**MEETING OF THE  
CONSERVANCY SCENIC CORRIDOR COMMITTEE  
Wednesday, August 19, 2020 at 7:00  
Village Hall, 3110 RFD, Old McHenry Road, Long Grove, Illinois**

**V. NEW APPLICATIONS:** CSCC 20-01; Consideration of the preliminary plans for the subdivision of property to be known as the "Phillip Estates" PUD (formerly Canterbury Park) and within the R-2 Residential District (reclassification required), including the location of Conservancy District Boundaries & pathways within Scenic Corridors & Conservancy Easements and native plantings on property commonly known as vacant property on the south side of Cuba Road submitted by the Phillip Estates LLC.

**RE:** August 19<sup>th</sup> - MEETING ISSUE REVIEW

RE: Philip Estates Subdivision  
Preliminary Landscape/Existing Tree Survey & Preservation Plan Review

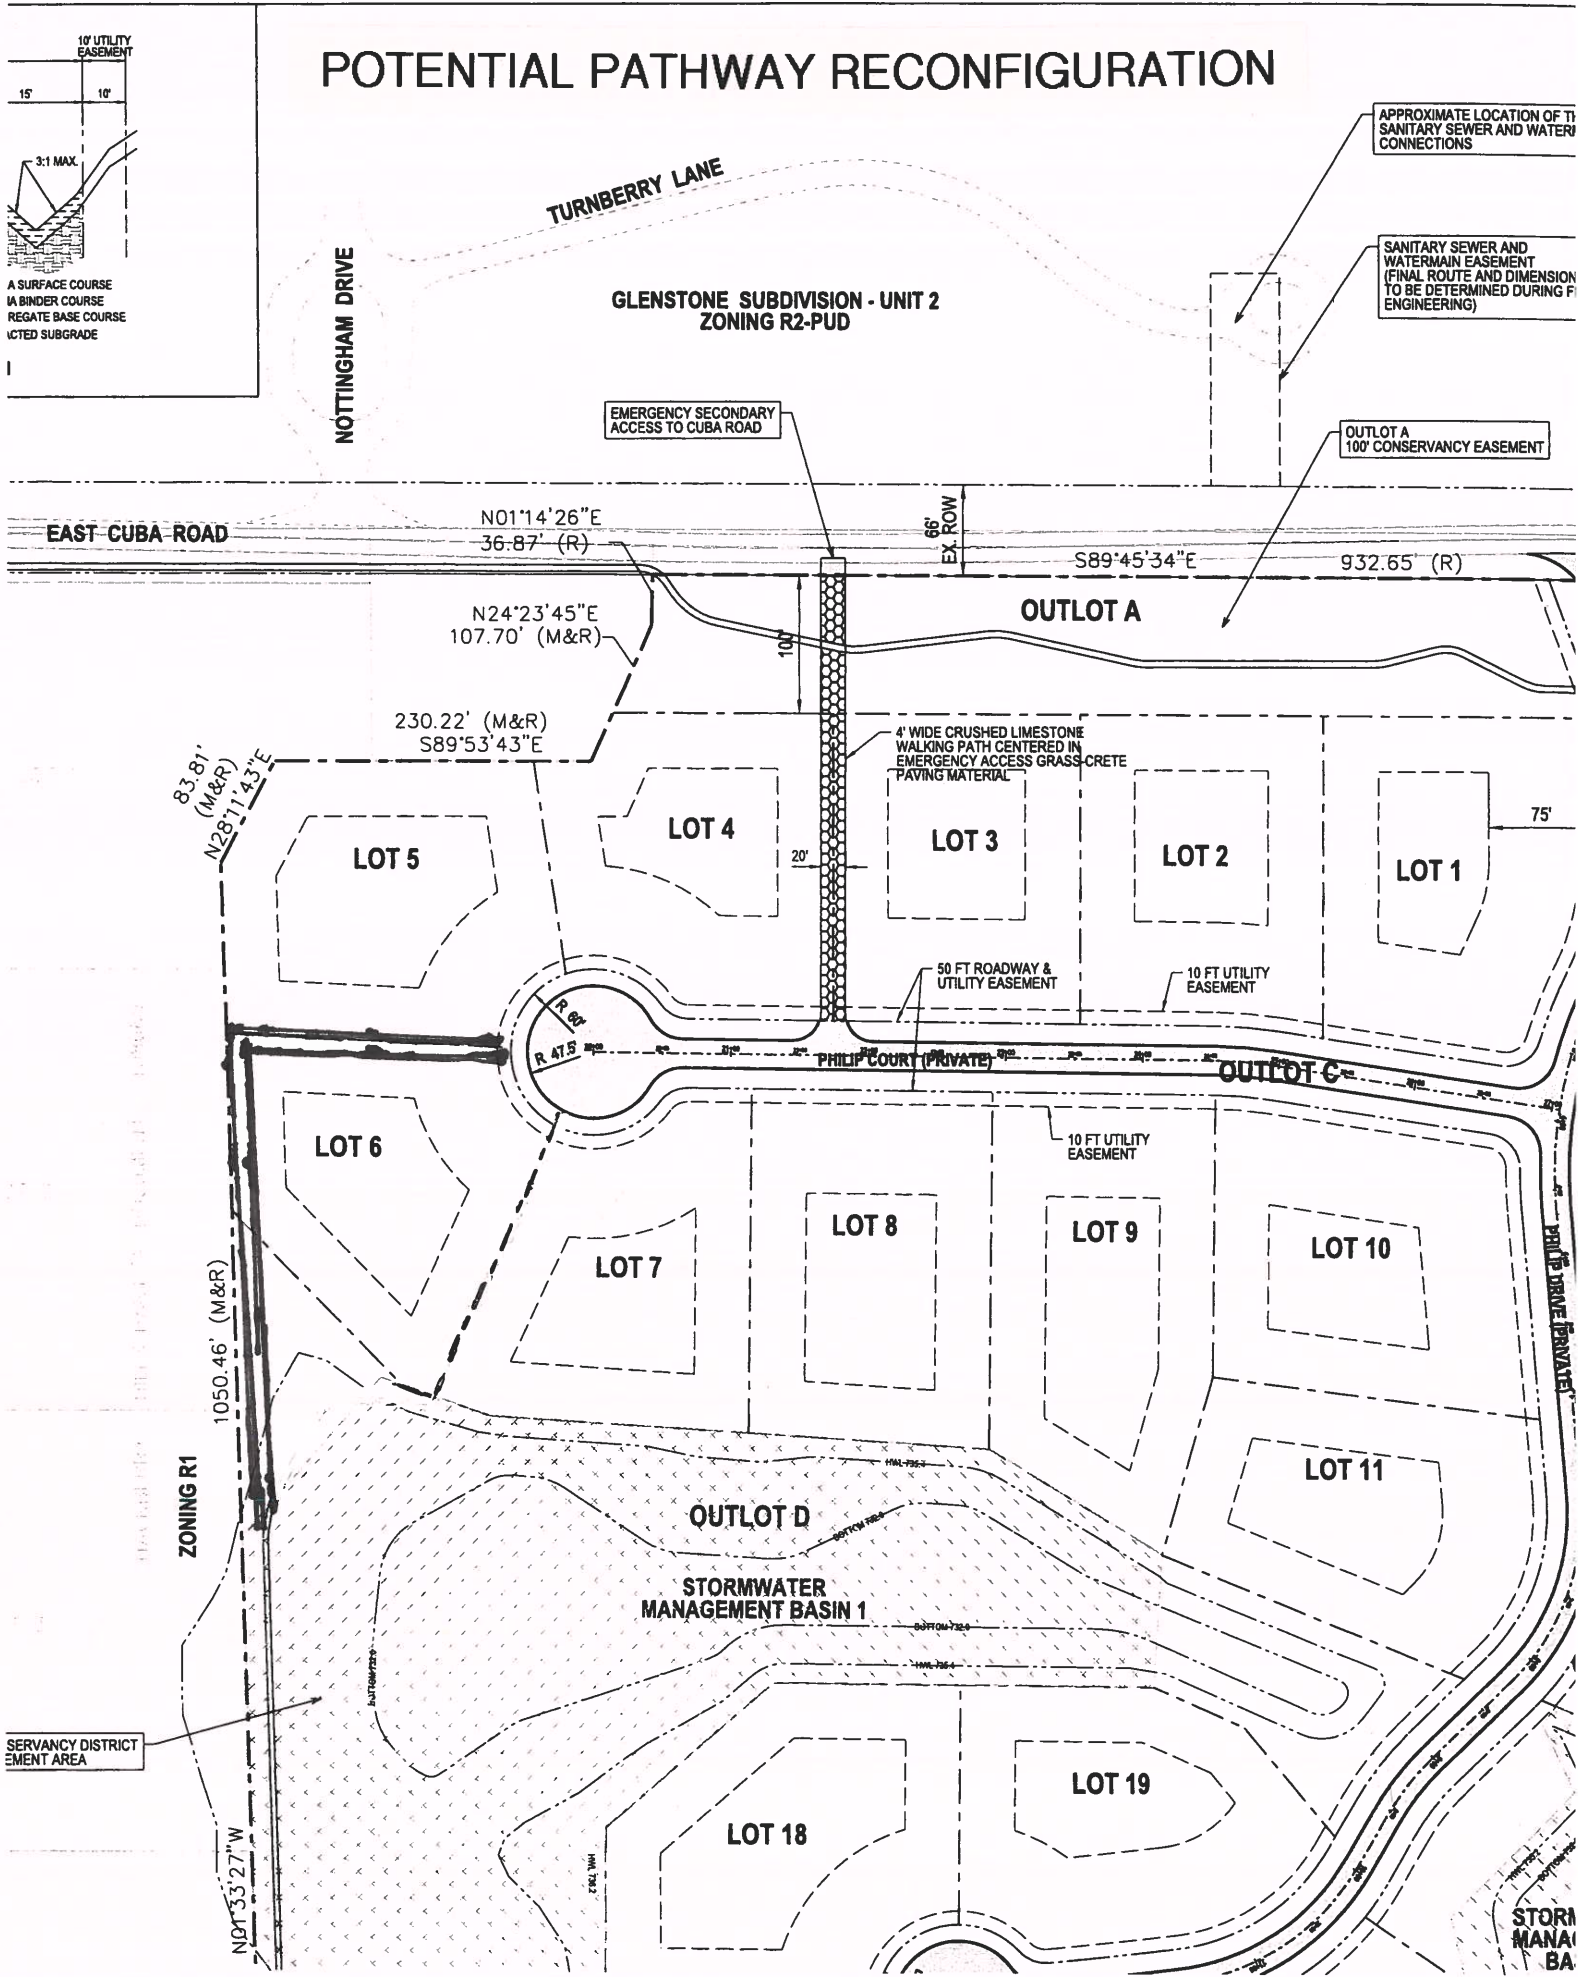
1. I will have to review the existing trees in the field to verify the data shown in the Existing Tree Survey.
2. The species of the proposed plantings are in general conformance with recommended acceptable species within the Village of Long Grove.

3. I would recommend the final Landscape plan include a detail that shows there will be a minimum of 6" -8" of topsoil within 2' of the outside edge of all root ball holes within the mass graded areas, such as the right of way. The top third of the root ball should be free of the metal basket, twine, rope and burlap after installation. Trees should be planted so that the top 2" of the root ball is above existing grade.

4. I would also recommend a Landscape Maintenance Specification to maintain the spirit and intent of the approved Landscape Plan. A schedule showing when the tree, shrub, prairie and wetland plantings will be installed, watered, pruned, mulched and otherwise maintained, to reach establishment, should also be included. All proposed plantings should be required to be replaced if in poor condition or dead, by whomever will maintain the common areas.

5. I will have to review the final grading and utility plans to determine which existing trees may require mitigation due to construction impacts.

CONSERVANCY SOILS EXHIBIT

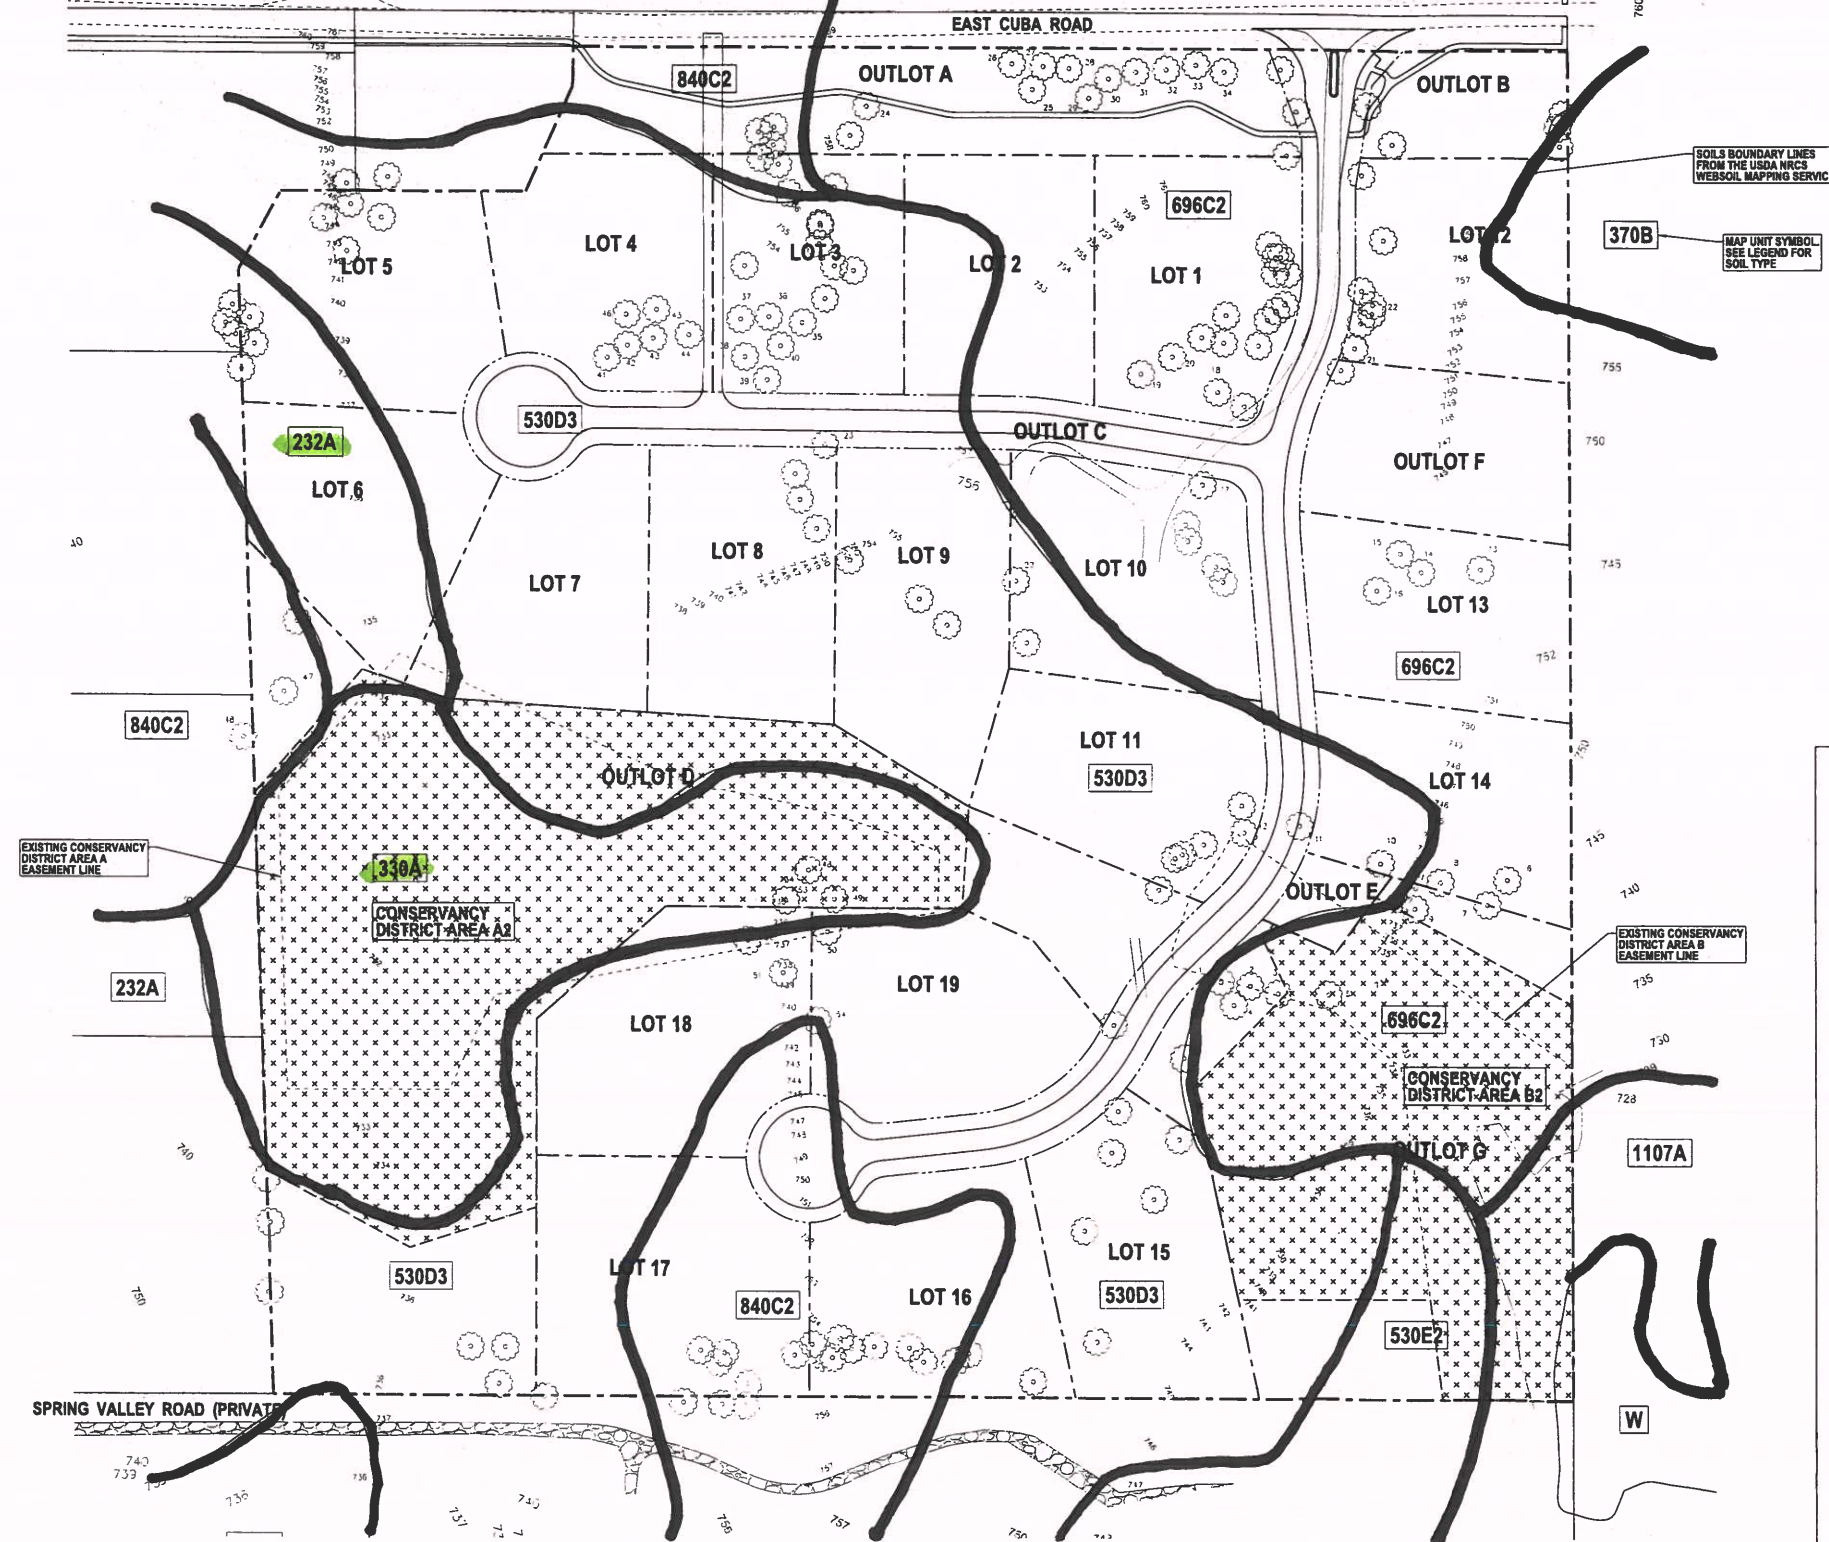
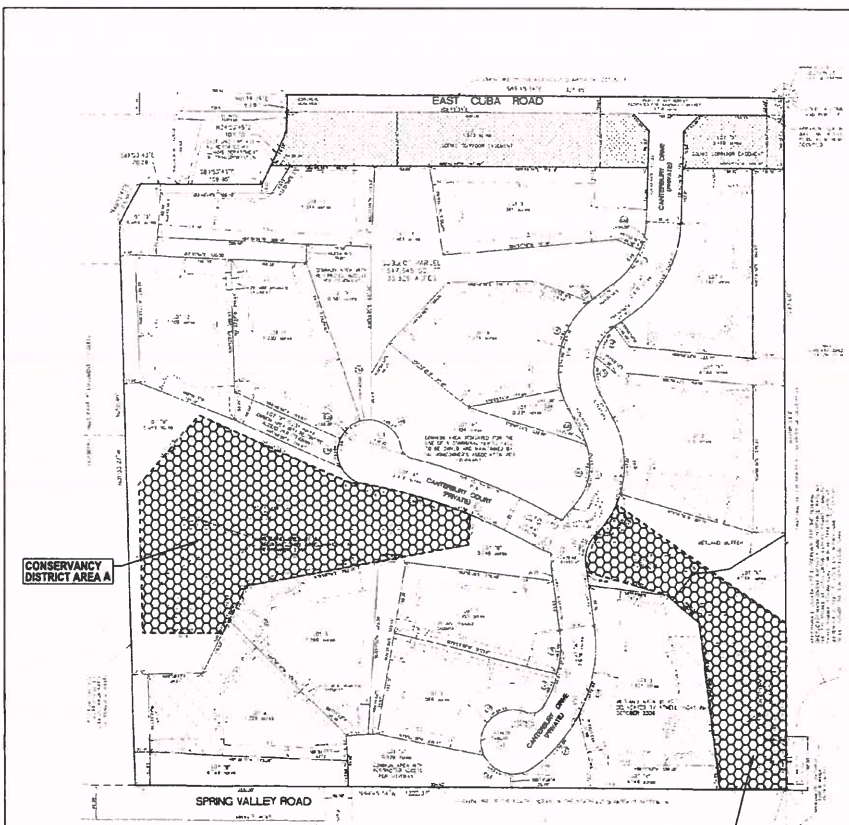
Conservancy soils and conservancy easements have, for the most part, been contained off private property and in common open space on both Outlots “D” & “G”. However, conservancy soils (232A) are also located on a large portion of proposed Lot 6 (42,205 sq. ft. including conservancy soils). However, Outlot “G” (155,187 sq. ft.) is in large part proposed as a conservancy easement and contains no conservancy soils.

As noted above the non-conservancy soils on Lot “G” serve to off-set the reduction in square footage of conservancy soils on Lot 6.

- Consider the conservancy district boundaries as identified on the preliminary plan and in particular the trade off with the proposed Lot 6. The CSCC should evaluate the “logical” boundaries for the conservancy easement boundaries as proposed. The CSCC has

considered modification to conservancy boundaries in exchange for enhancements to the conservancy easement (in the form of native plantings), enhanced scenic corridors or possibly pathways and/or other site improvements **prior to platting**. The CSCC should review and approve the plantings proposed for the conservancy area (which also are stormwater detention areas) and the plantings in the scenic corridor.

# POTENTIAL PATHWAY RECONFIGURATION

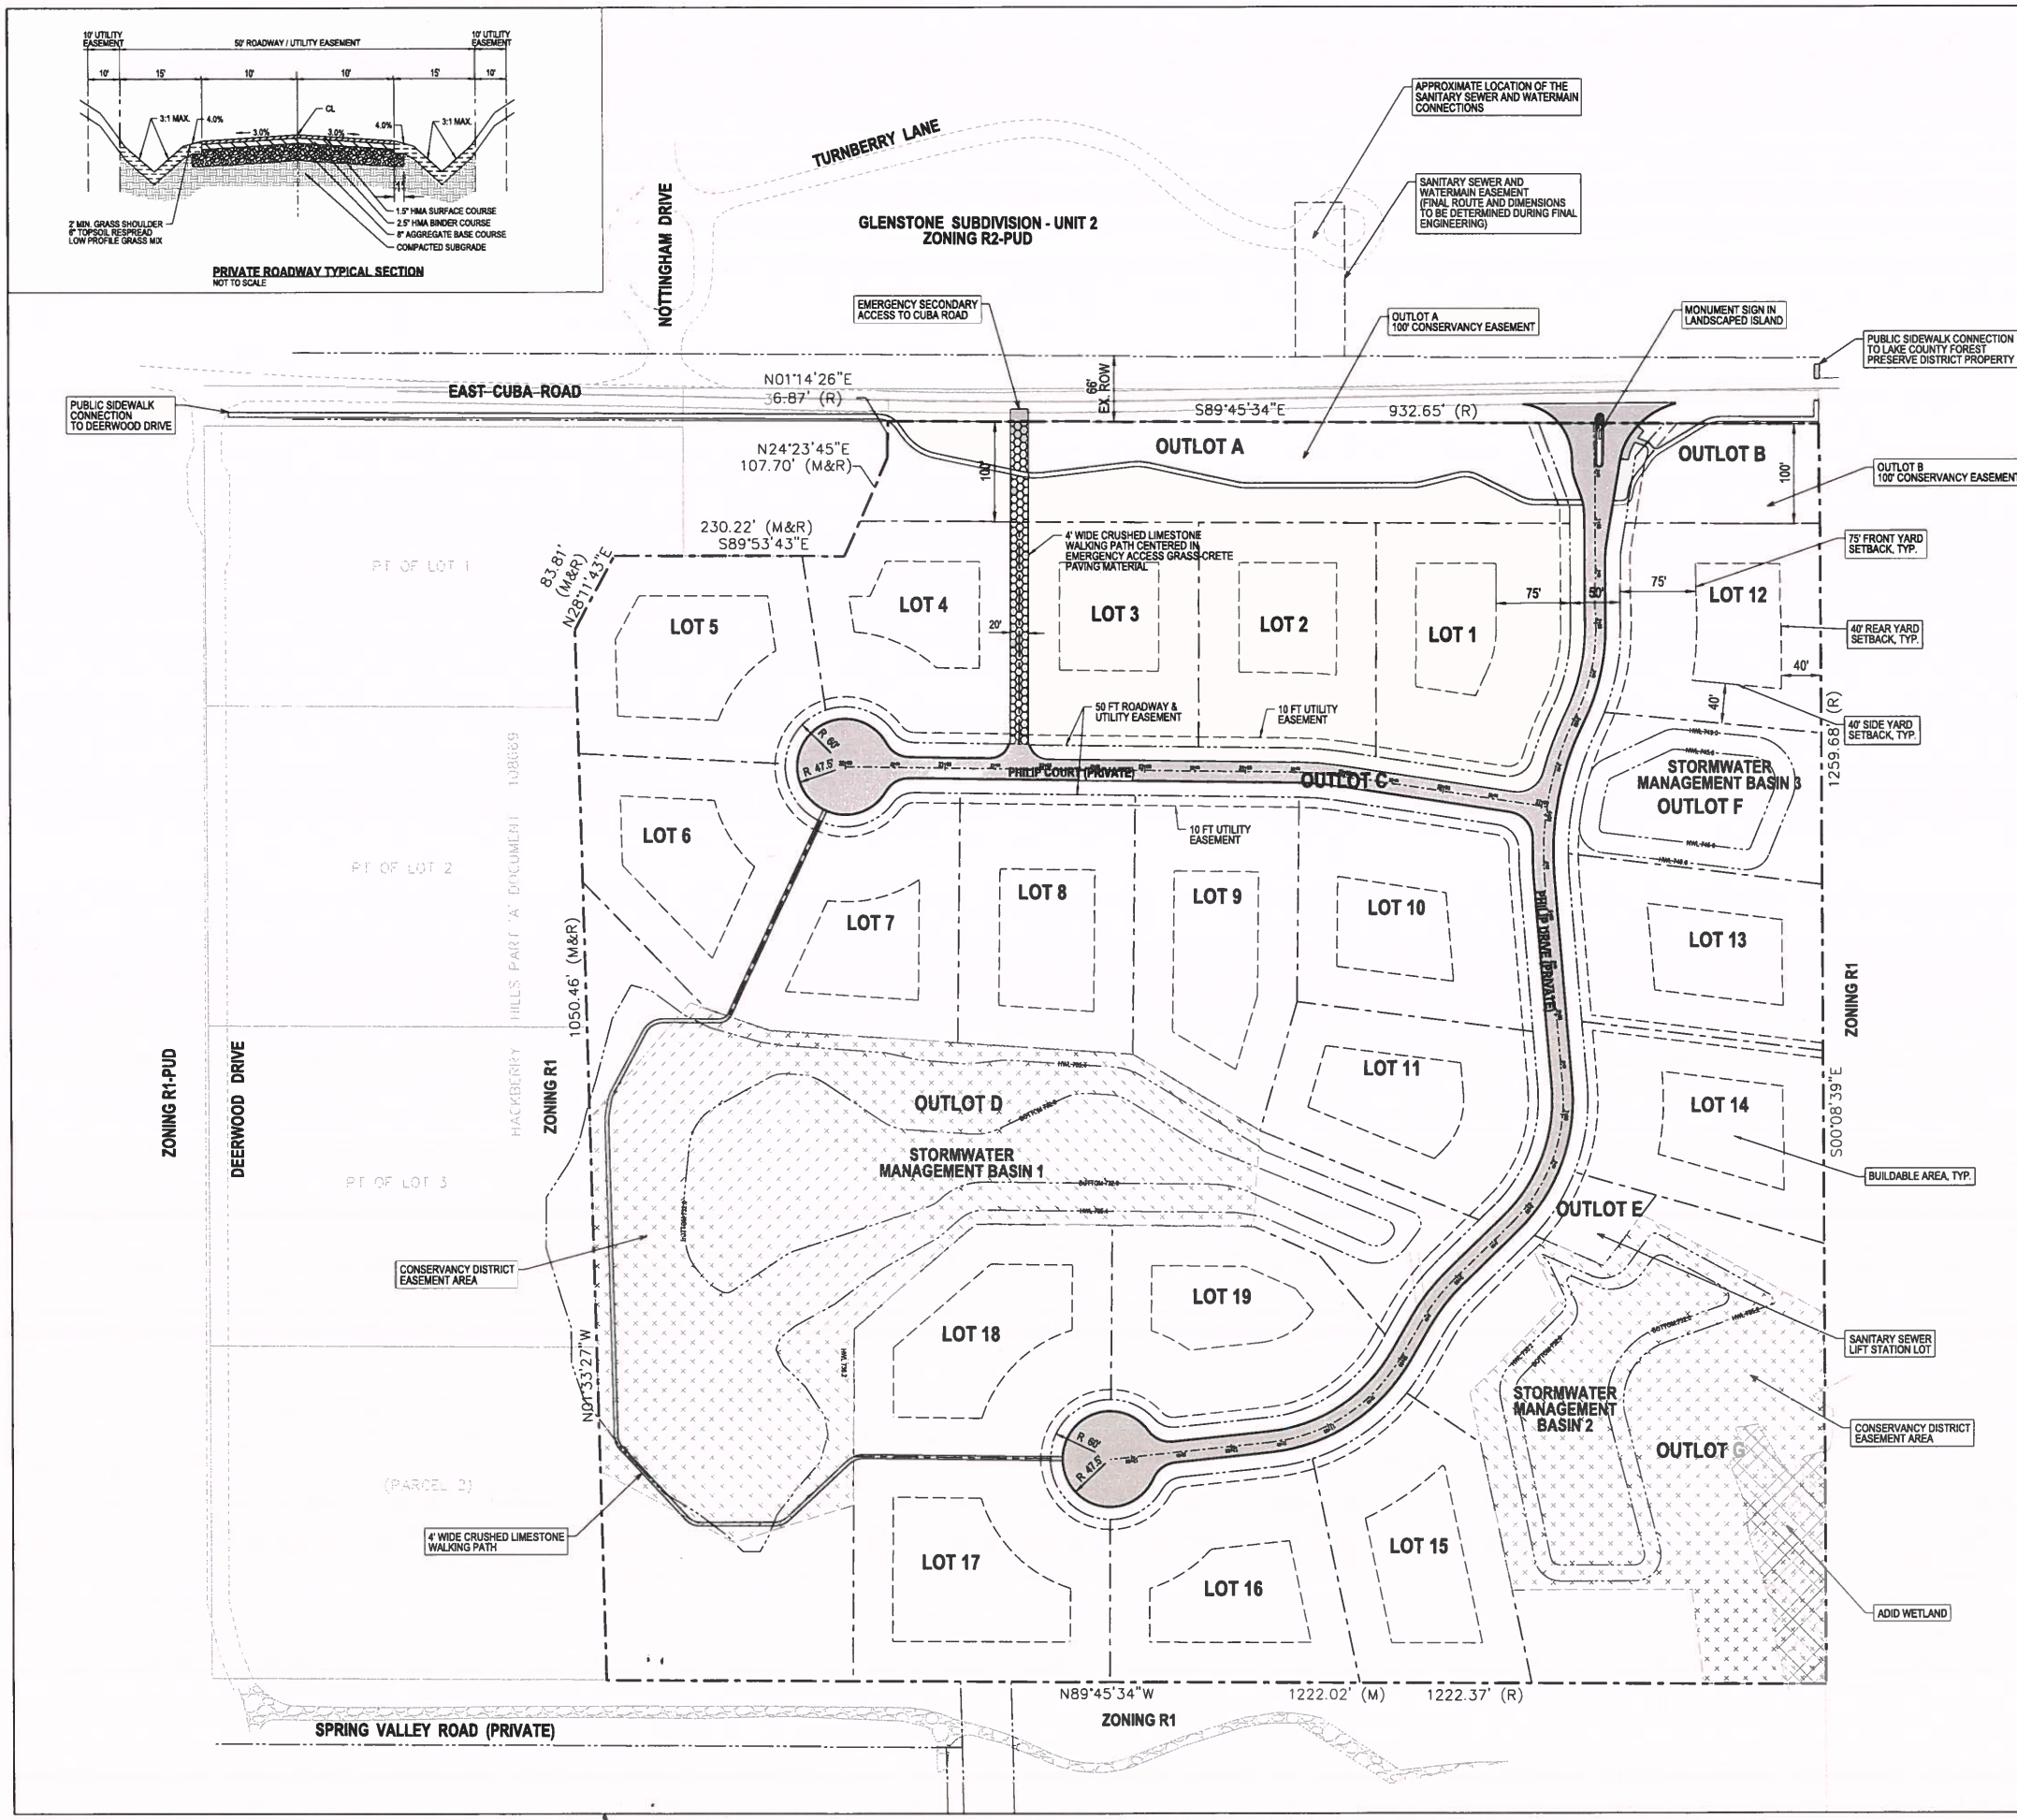
With the apparent demise of the Route 53 Extension (adjacent to the west line of the development), staff suggests consideration of reconfiguring the pathway segment on “Outlot D”. As proposed this pathway segment runs across the south end and up the west side of the outlot then continuing between Lots 6 & 7 to connect with the internal access road ultimately forming a loop pathway segment.

Consideration should be given to continuing the pathway segment along the west side of the outlot and the west lot line of Lot 6 then heading east, between Lots 6 & 7 to form a loop with the internal access road. Should pathways ultimately become part of the Route 53 Extension R.O.W. a pathway “stub’ would exist for connectivity to a future pathway to the west.
